# MEMORANDUM

**RE:** Waterfront West Overlay District –  
Building Heights, Setbacks, Commercial Area, Accessibility and Uses

Nandi height illustration – existing zoning (from Port email of 11/19/18)

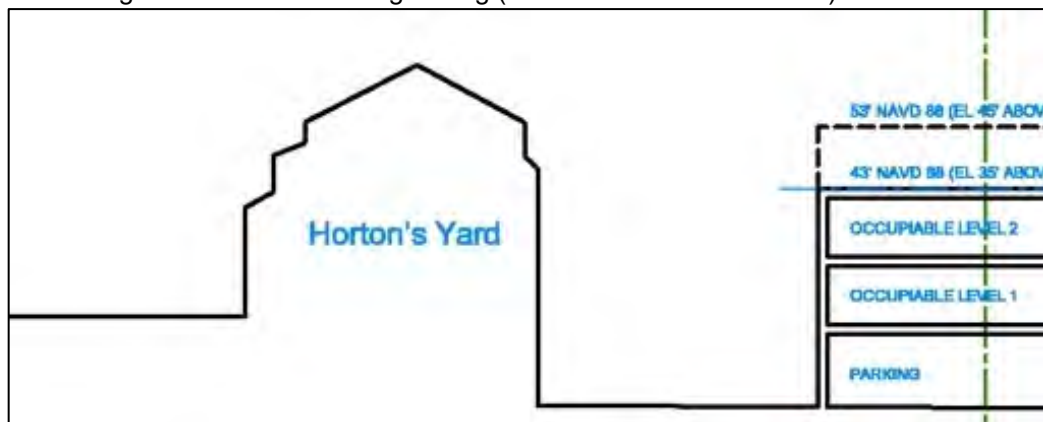
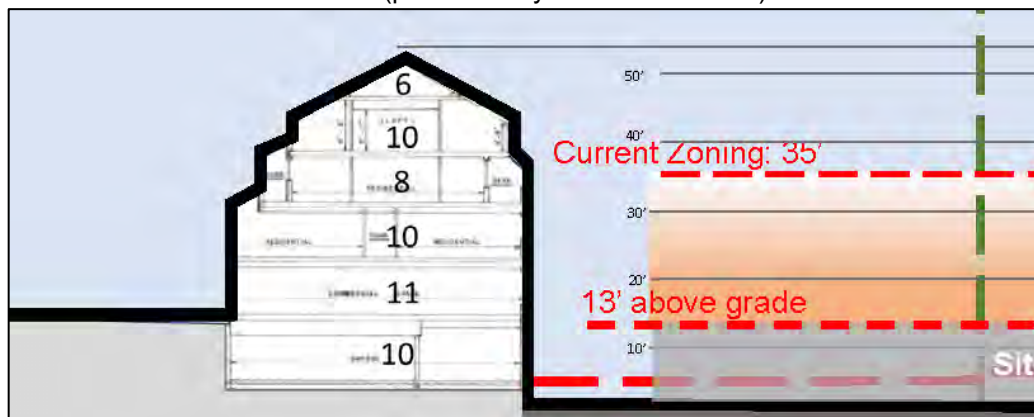
While Rishi's illustrations could be interpreted as showing a horizontal separation between the two buildings of around 45 feet (based on the vertical scale), the site constraints illustration that NED presented at the Ad Hoc Committee's November 15 meeting shows a separation of only 18 feet. This difference may be seen by comparing the following excerpts from the two illustrations:

Certainly, what might be acceptable with a 45-foot separation would have much more impact on the abutting property if the separation were reduced to less than half that distance. This reinforces Andy's point about stepping back buildings in proportion to their distance from property lines, and the same argument also applies to stepbacks along side and rear property lines.

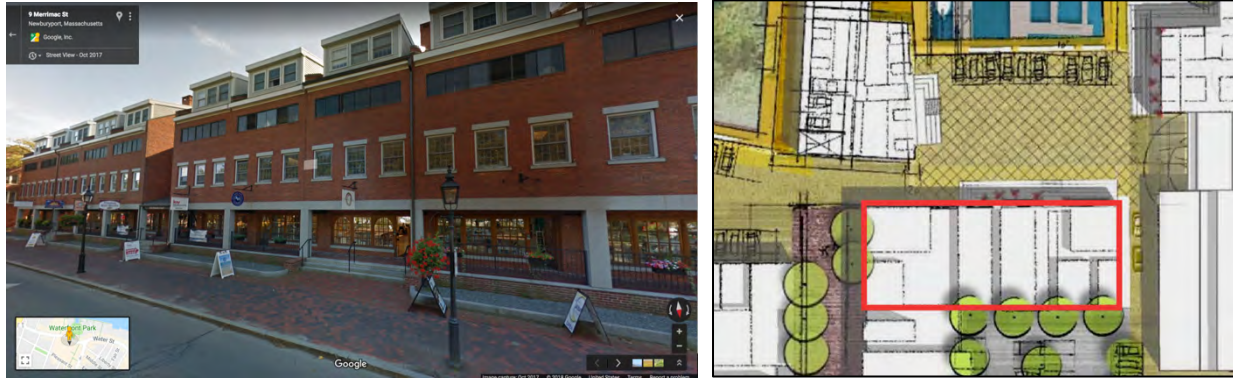
To provide a public benefit, this development has to include fully active street frontages in two parts of the site: along the existing walking route between the Route 1 underpass and the central waterfront, and along Merrimac Street. The numbers that are being talked about for commercial floor area are very low: 5,000 sq. ft. is surely too little retail space for this area (it is 30% less than the combined floor area of Richdale, Angie's and Annie's), and 10,000 sq. ft. is not too much. This is another case where the abstract metrics are meaningless in the absence of good design and attention to function

On NED's August 2018 plan, the principal commercial frontage facing the water (see image below right) appears to be about 140 feet wide by 55 feet deep, for a building footprint of 7,700 sq. ft. It could thus accommodate 7 storefronts similar to those at Merrimac Landing (along with a lobby for the upper floor residential units)
